ADDENDUM NO. 4

**PROJECT: GROVE CREEK WPCP
FOR CITY OF COMMERCE
GMC PROJECT NO. CATL230033**

- 7.2 This is the end of Addendum No. 4, dated May 12, 2025.

**CIVIL SITE PLAN -
 INFLUENT PUMP
 STATION GRADING PLAN**
CU-201

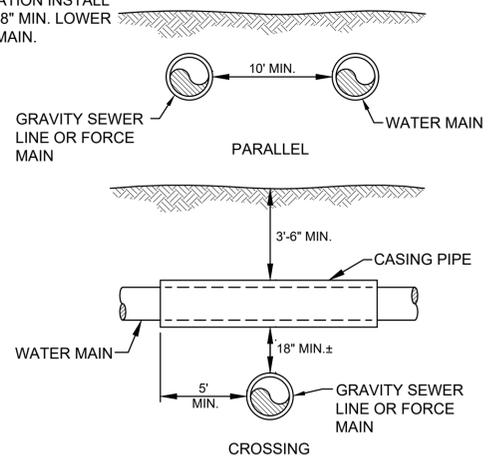
- 4.1 Drawing sheet CU-201: Add Gravel Limits
4.2 Drawing sheet CU-902, CU-904: Modify details

- 5.17 **Where is the Access Road in Detail G/CU902 required to be installed? Is this a permanent or temporary application?**
See revision of CU-201. 4" GAB within pump station will be permanent.

- KEY NOTES:** #
1. PROPOSED WETWELL
 2. PROPOSED VALVE VAULT
 3. PROPOSED ELECTRICAL BLDG.
 4. PROPOSED GENERATOR AND CONC. PAD
 5. PROPOSED 30" DIP CONNECTION LINE
 6. PROPOSED 16" INFLUENT FORCE MAIN
 7. FUTURE 16" INFLUENT FORCE MAIN
 8. 12" x 12" MJ TEE
 9. 20' WIDE ACCESS GATE
 10. 3 STRAND BARBED WIRE CHAIN LINK FENCE PERIMETER FENCING. PLACE 1'-0" INSIDE PROPERTY BOUNDARY WHERE APPLICABLE
 11. DEMO EXISTING FENCING
 12. PERMANENT UTILITY EASEMENT AND PROPERTY BOUNDARY
 13. TEMPORARY CONSTRUCTION EASEMENT
 14. 25' UNDISTURBED VEGETATIVE BUFFER FROM WRESTED VEGETATION
 15. PRE-FABRICATED ALUMINUM STAIRS
 16. HANDRAILS
 17. 4" GAB LIMITS (3200 SF) 3

B **DETAIL - CASING & CARRIER PIPE**

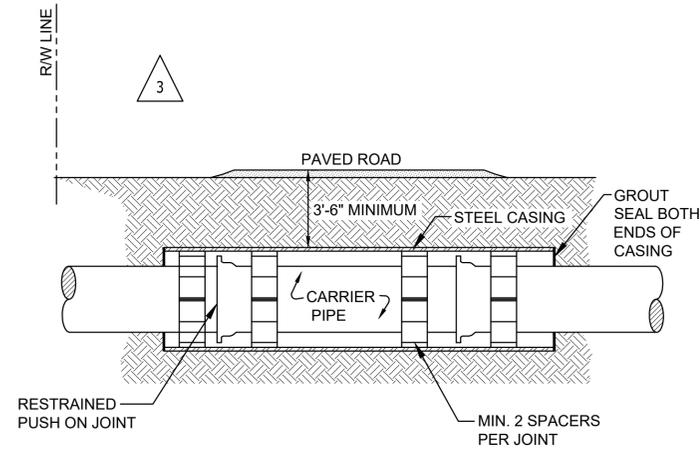
- 5.14 **Will GDOT require grout filling of annular space for steel casing in GDOT ROW?**
No grout filling required except as shown in detail (casing spacers and rest jt. mandatory)

- 5.15 **Will vent pipe of steel casing shown in Detail B/CU902 be required for steel casing in GDOT ROW?**
No vent piping required.
- 5.16 **What is size of vent pipe in Detail B/CU902?**
No grout filling or vent piping required on any steel casing.
